CITY OF BEAUFORT HISTORIC DISTRICT REVIEW BOARD PROJECT APPLICATION (Revised - 07/15/2011)

Property Address: 209 West Street, Beaufort, South Carolina 29902 R120-004000-0923000

CITY OF BEAUFORT
Historic District Review Board
Full Board
Staff Report
Meeting of August 12, 2015

Case Number: HR15-24
Property Address: 209 West Street
Applicant: Beaufort Design Build
Type of Request: New Construction - Conceptual
Zoning: CC – Core Commercial

PROPOSED EXTERIOR BUILDING ELEVATIONS

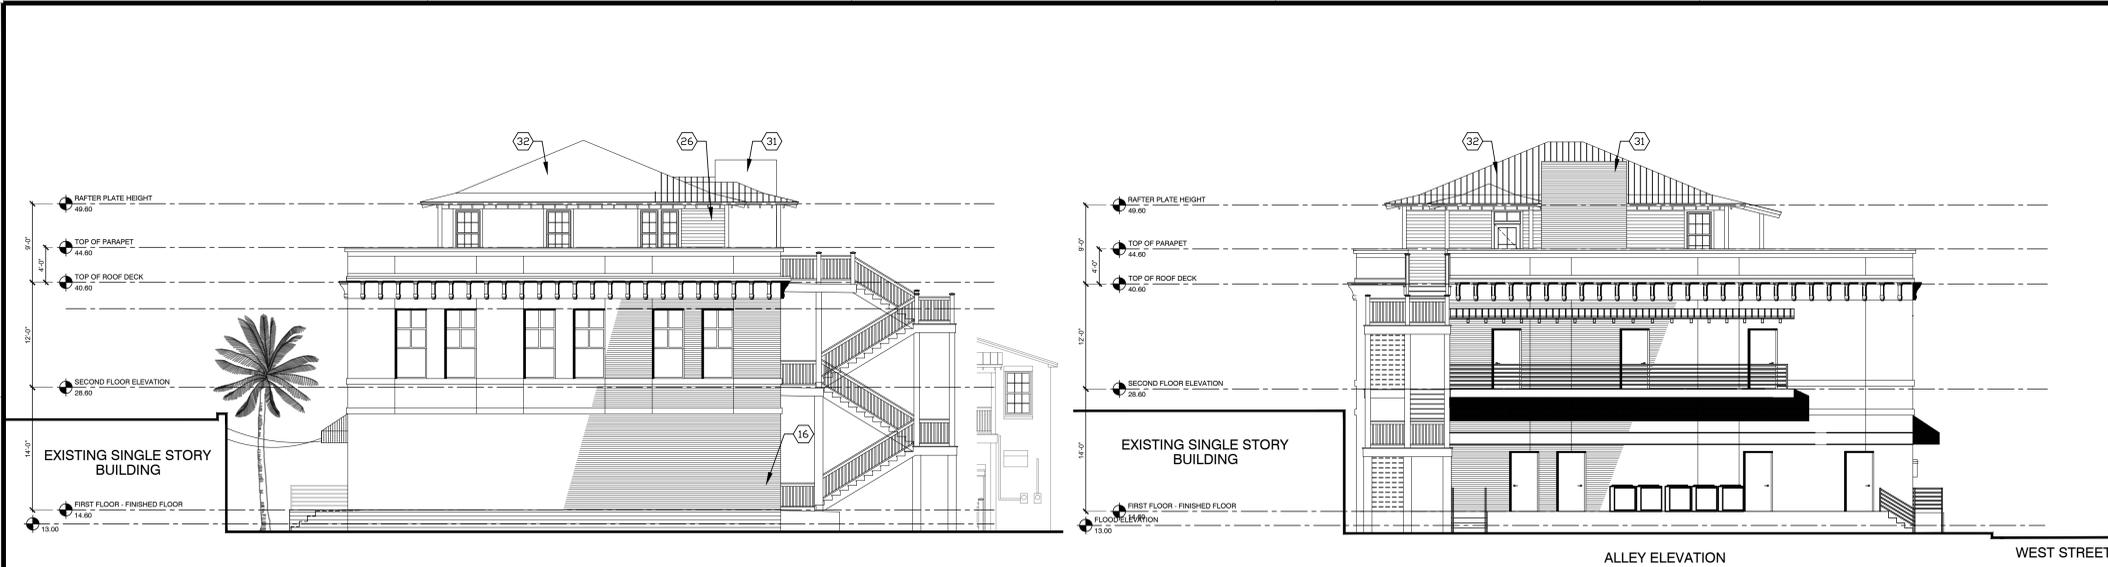
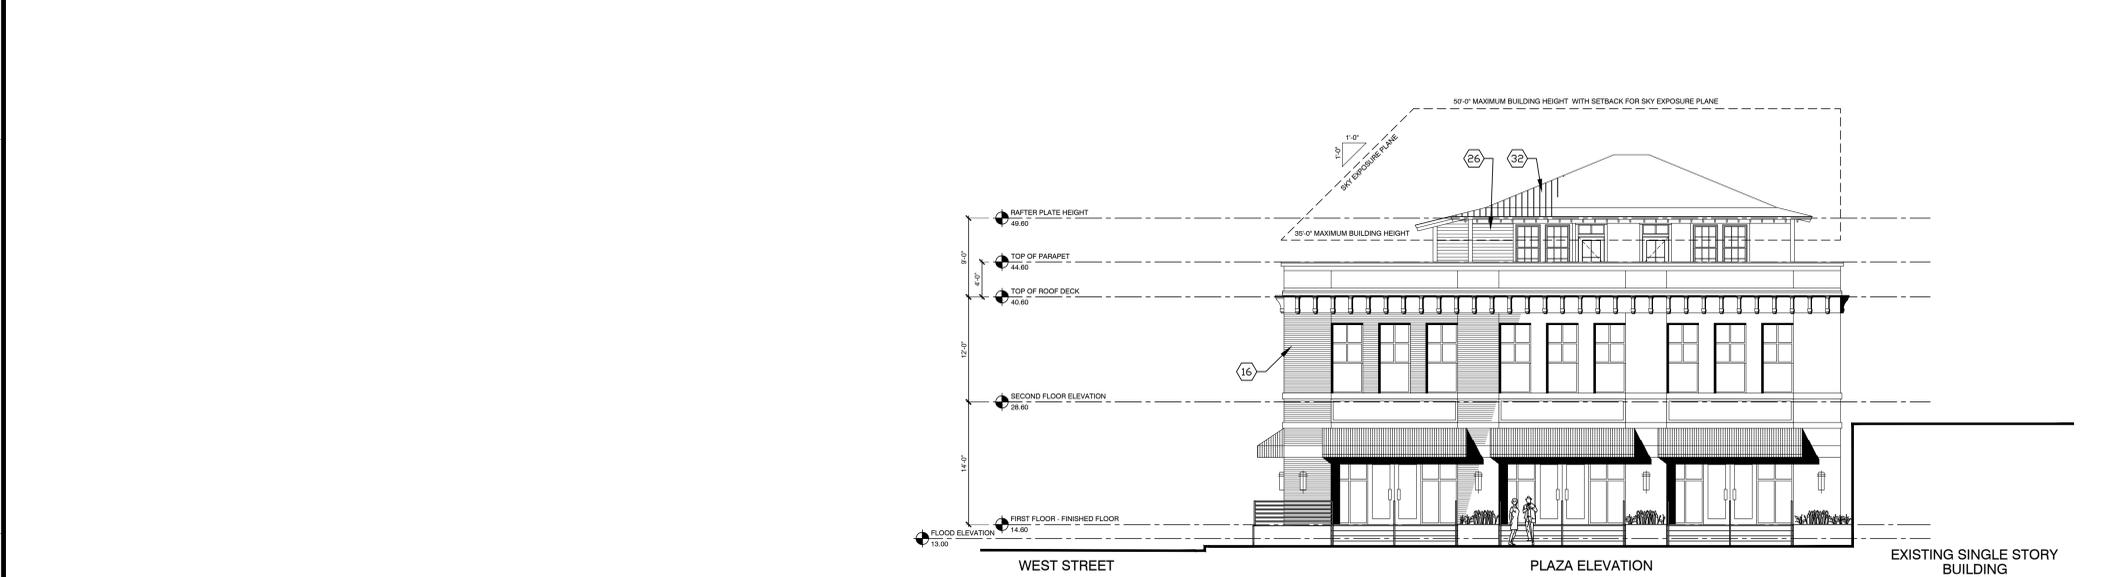
Size: The footprint of the structure is approx. 3,078 SF, with a 3, 078 SF 2nd floor. The 3rd floor would be stepped back, and contain 1,236 SF. The building is 32' above sidewalk grade, and increases to 45' to the median roof height at the stepped-back 3rd floor.

- This building is sited appropriately, and addresses the increased height requirement due to the Base Flood Elevation appropriately.
- In general the size, mass, scale, proportions of the building, windows and openings are all compatible with the historic district.

- Staff appreciates the effort to step the building back more than the required distance, and also use lighter materials in the third story form.
- The open stair in the rear is an appropriate solution for egress in lieu of a tower.

Staff recommends conceptual approval as submitted to the site plan and building.
